| Project: Town of Pendelton Community Center | Contract Name: Electrical Contract |

Attachments: CIR-COR #11 - Exterior Distribution Equipment Relocation

CHANGE ORDER REQUEST RECAP

Change Order Request No.: 11

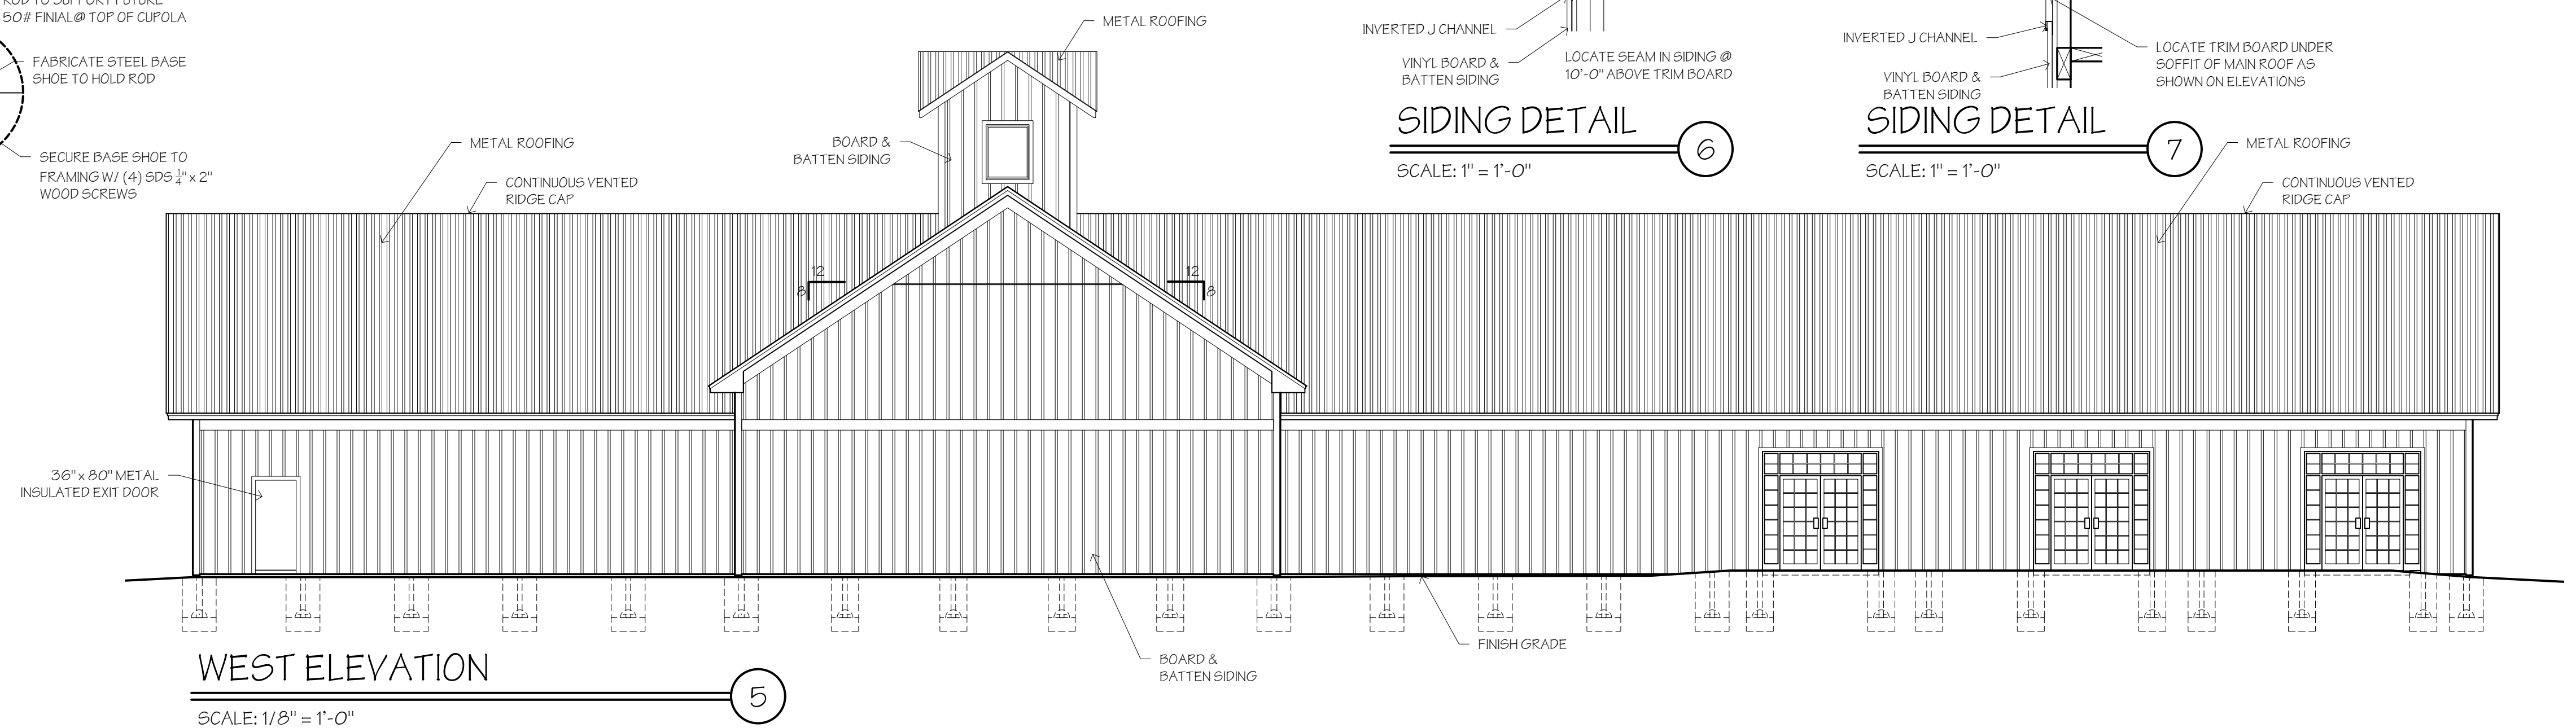
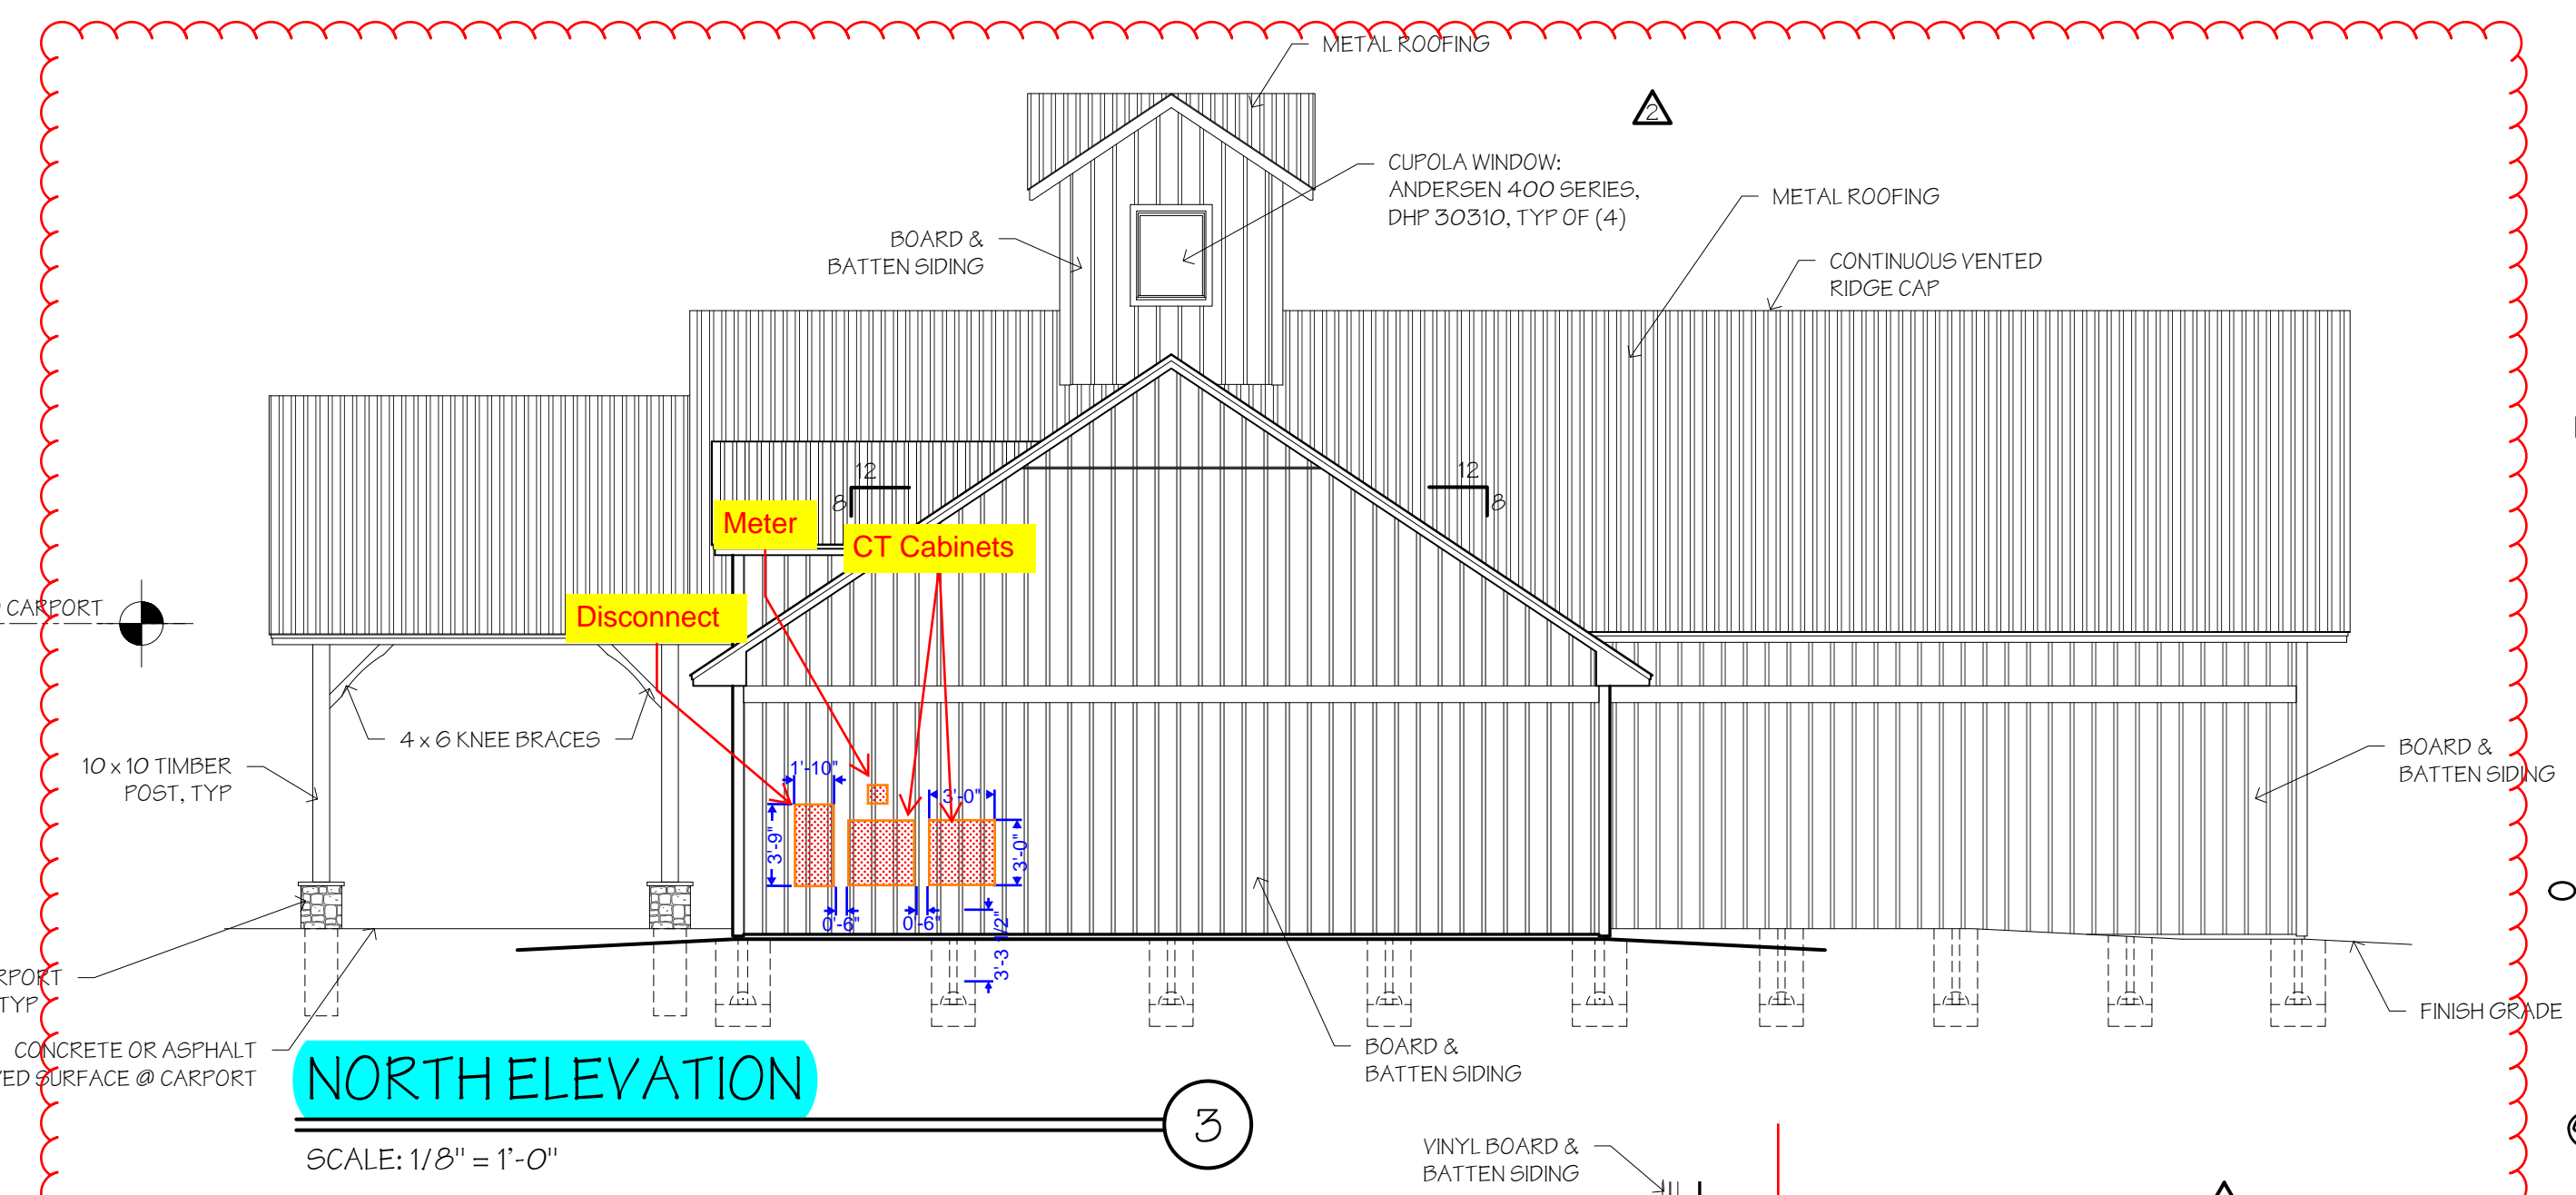
CIR to relocate existing exterior distribution equipment from east side of the community center (front), to the north side of the building. CIR to extend feed from exterior disconnect to MDP to accommodate relocation of equipment. Underground conduit length remains unchanged.
